Re: Comments on Report for HDD PA-DE-0100.0000-RR (HDD# S3-0620)

Pursuant to the Corrected Stipulated Order entered on EHB Docket No. 2017-009-L on August 10, 2017 (“Order”), and on behalf of Clean Air Council, Mountain Watershed Association, Inc., and the Delaware Riverkeeper Network (“Appellants”), please accept these comments on Sunoco Pipeline L.P.’s (“Sunoco”) re-evaluation report (“Report”) for the horizontal directional drilling (“HDD”) indicated by drawing number PA-DE-0100.0000-RR (the “HDD Site”).

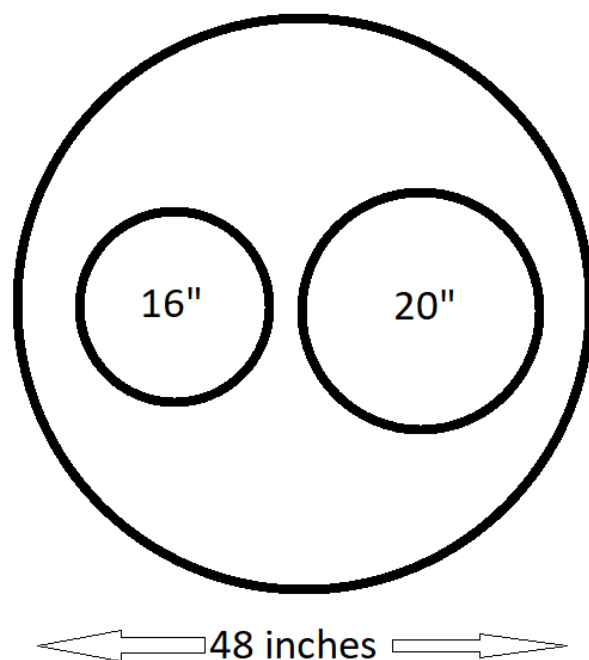
Direct pipe requires a larger pipe than the 16" and 20" themselves, since it sends cuttings and slurry back through the interior of the pipe along an apparatus. Sunoco is planning on installing a 48" interior diameter pipe through direct pipe and then snaking in the 16" and the 20". The cross-section would look something like this:

There is no way to arrange these three pipes so that they are not within at most four inches of each other at any given point. Given Sunoco's description that the carrier pipes would be suspended within a spider gasket, they will necessarily be closer than 12 inches apart.

The Pipeline and Hazardous Materials Safety Administration (PHMSA) requires more than that level of clearance:

§ 195.250 Clearance between pipe and underground structures.

Any pipe installed underground must have at least 12 inches (305 millimeters) of clearance between the outside of the pipe and the extremity of any other underground structure, except that for drainage tile the minimum clearance may be less than 12 inches (305 millimeters) but not less than 2 inches (51 millimeters). However, where 12 inches (305 millimeters) of clearance is impracticable, the clearance may be reduced if adequate provisions are made for corrosion control.

It would not be impracticable to install the two pipes separately. That is exactly how Sunoco has planned to install the pipes *in every other location*. Using the same sized casing pipe would leave enough clearance to comply with the federal safety regulations.

Nonetheless, a compliant pipe diameter is not what is planned here. This presents safety issues including corrosion and cathodic protection. The carrier pipes within the casing pipe tend to be more prone to condensation or water infiltration, causing corrosion, and the closeness between the pipes can interfere with the cathodic protection system. See, e.g., *Materials Performance*, “Challenges of Installing a New Pipeline,” March 29, 2018, available at <http://www.materialsperformance.com/articles/cathodic-protection/2018/04/challenges-of-installing-a-new-pipeline>. This does not mean that casings are always to be avoided, but Sunoco’s plan to bundle the two carrier pipes within one casing over long distances in a residential neighborhood where the pipes could be laid separately appears foolhardy. Also, assuming a rupture did occur, the gas would likely collect in the casing pipe and funnel out at the entry or exit of the direct bore. For the segment under the railroad, that would be in a residential neighborhood on one end and at the other end in the middle of the high-density Tunbridge Apartment complex.
